**WKF2 - Replacing Pulse Sender (Workshop Campaign)**

Vehicle Type: **911 (992)**

Subject: **Pulse sender**

*Installation position of pulse sender***1** – Pulse sender (replace)**Parts required****NOTICE****Using a pulse sender that has not been adequately tested**

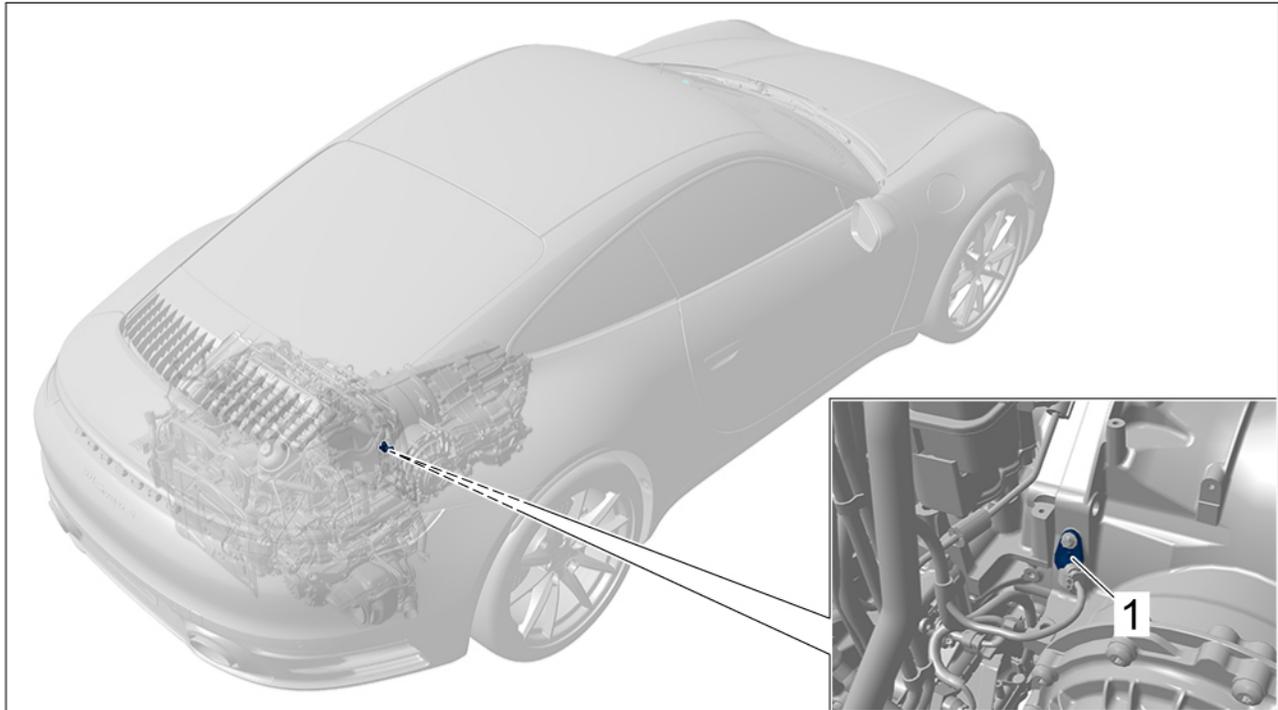
Information: **Due to a manufacturing problem with the pulse sender for the crankshaft, there is a possibility that the engine will be difficult to start and as a result, engine power will be reduced on the affected vehicles.**

Remedial Action: Replace pulse sender.

- Measure is ineffective
  - Engine control fault even after replacing the affected component
- ⇒ Check the marking on the new pulse sender before installing it.
- ⇒ Only pulse senders marked with a blue dot may be installed.
- ⇒ Pulse senders with a white dot or with no marking have not been adequately tested and must not be used.

- 2 Remove pulse sender and **install new pulse sender marked with a blue dot**.  
For instructions, see ⇒ *Workshop Manual '287319 Removing and installing pulse sender'*.
- 3 Lower the vehicle and remove it from the lifting platform.
- 4 Enter the campaign in the Warranty and Maintenance booklet.
